Updated site plan Badgers Lodge , The Street, Thakeham, RH20 3EP

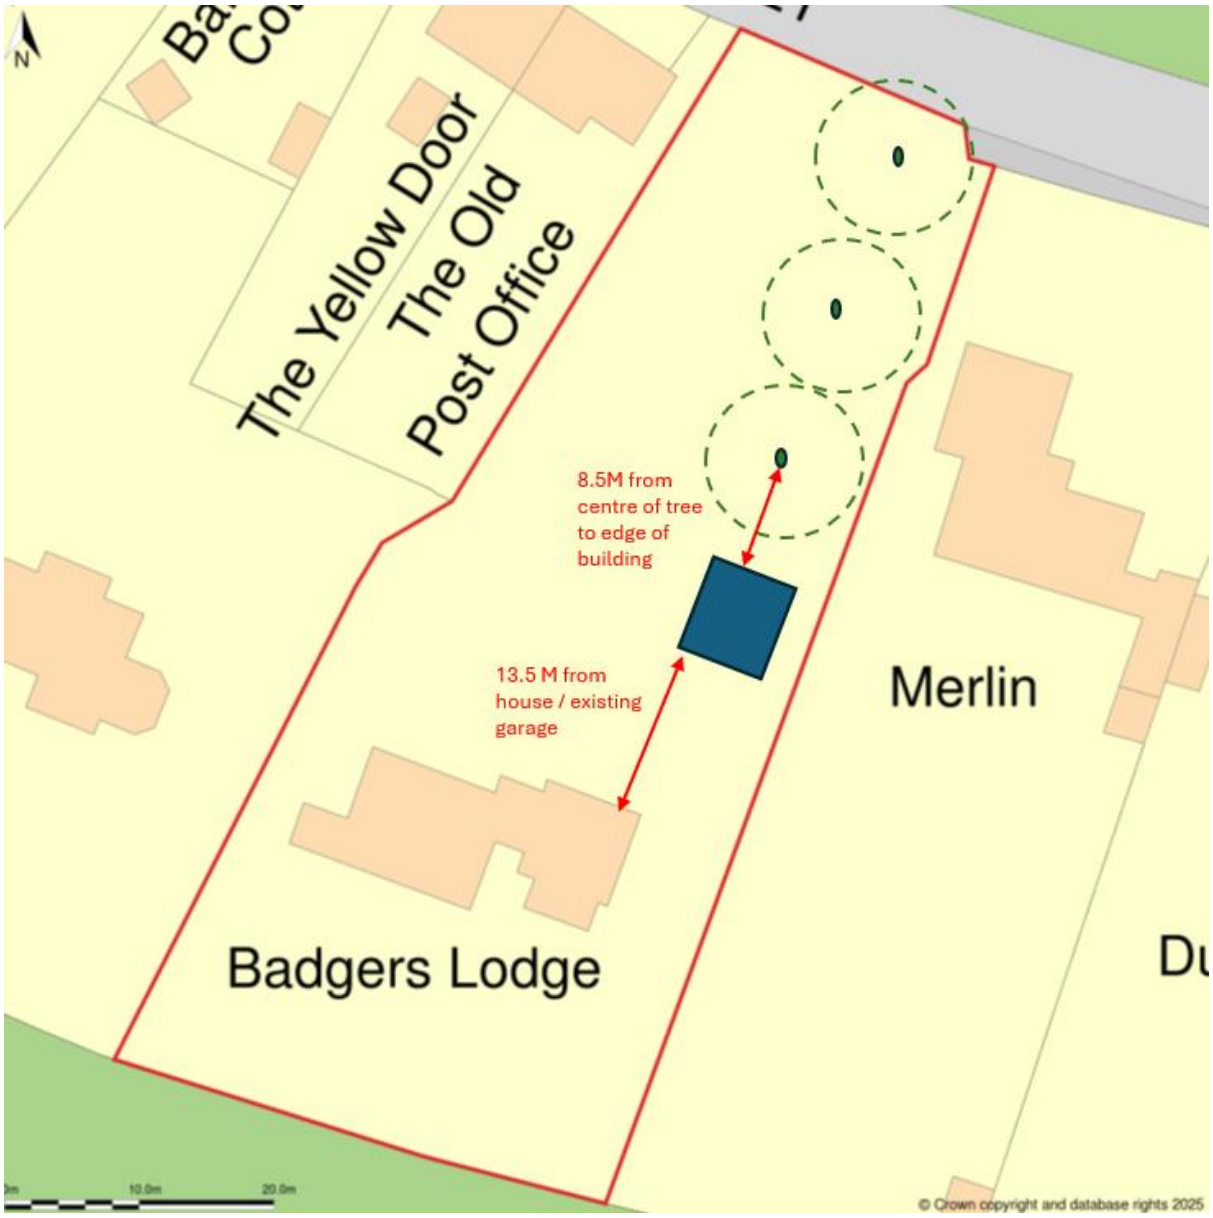
Following meeting and consultation with Horsham District Council Arboricultural Officer . Was agreed to amend the position of the proposed development, to avoid protect the root protection area of the adjacent Sycamore tree.

The updated plan shows the new proposed location of the building, in relation to the tree (and existing dwelling for reference.) Was also agreed that the remaining area within the root protection area would remain as a permeable surface. Ie Grass , Gravel or Bark chipping, to improve the moisture catchment and health of the tree.
